## Report of the Chief Planning Officer

Date: 26<sup>th</sup> April 2018

**Subject: 16/06951/FU - Demolition of existing buildings and construction of six apartments with associated access, landscaping and car parking at 7 Wakefield Road, Garforth.**

**DRAWING TITLE**  
PROPOSED SITE PLAN

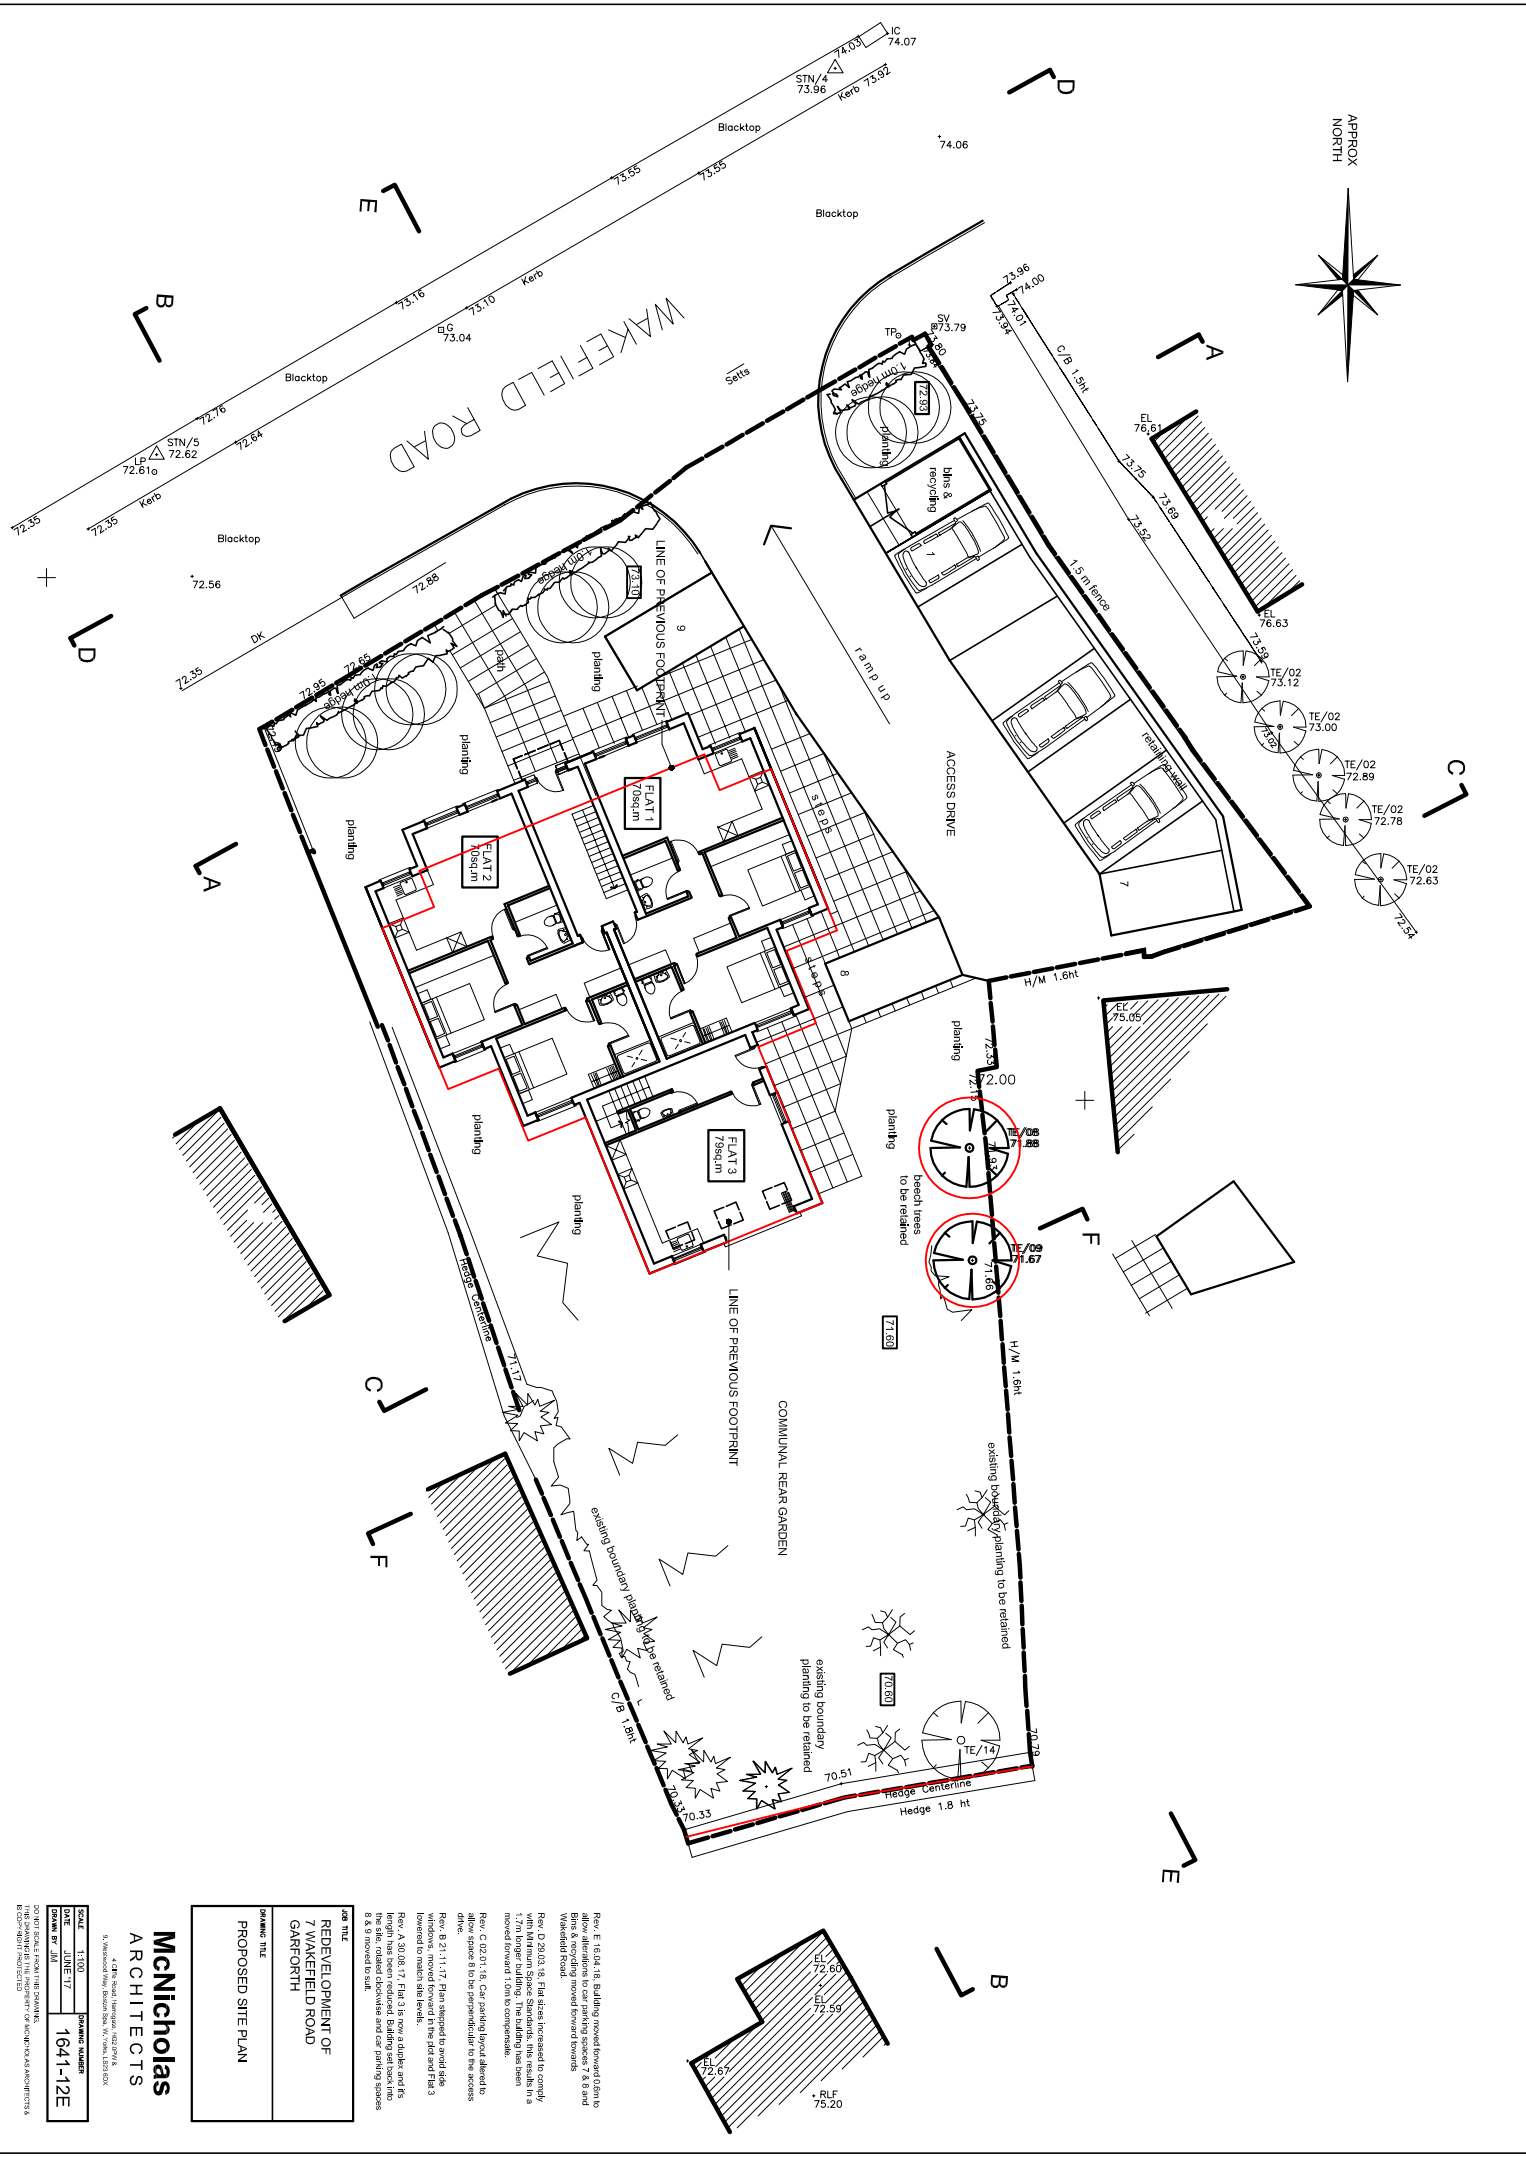
Rev. E 16.04.18: Building moved towards Dean to allow alterations to car parking spaces 7 & 8 and widened front.

Rev. D 20.03.18: Flat 2 has been moved forward towards front.

Rev. A 30.06.17: Flat 3 is now a duplex and its length has been reduced. Building set back into the site, raised driveway and car parking spaces moved forward 1.0m to compensate.

Rev. C 02.01.18: Car parking layout altered to allow space 8 to be perpendicular to the access drive.

Rev. B 21.11.17: Plan adapted to avoid side boundary.
